Interactive comment on “Catchment-scale groundwater recharge and vegetation water use efficiency” by Peter A. Troch et al.

Peter A. Troch et al.

Interactive comment on *Hydrol. Earth Syst. Sci. Discuss.*, <https://doi.org/10.5194/hess-2018-449>, 2018.

Fig. 1. Histogram of the coefficients of variance (CV) of the annual k-values for all catchments

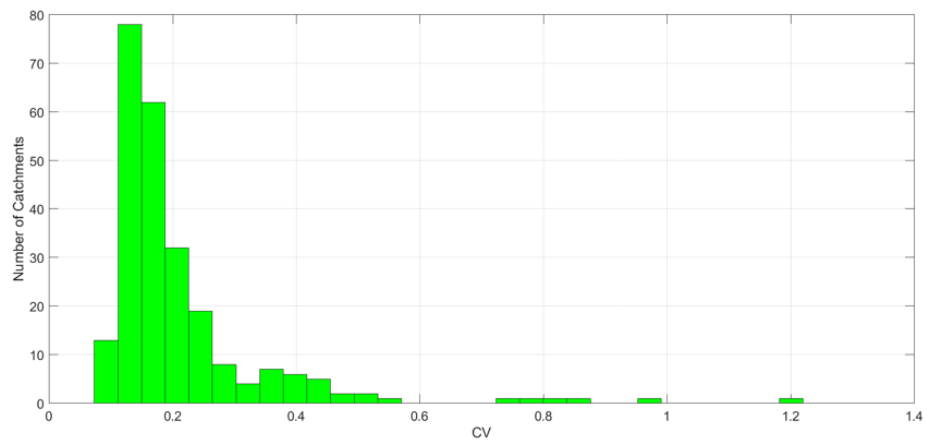
"L227: How variable were the determined k-values between years, within individual catchments? Were those variations somewhat realistic (since one can expect them to be fairly constant, right?)."

Figure 1 shows that the interannual variability of the obtained k values is quite small (all values of the coefficients of variance are much less than 1, except for one catchment). We mention this already in the manuscript and will consider to add this figure to the revised version.
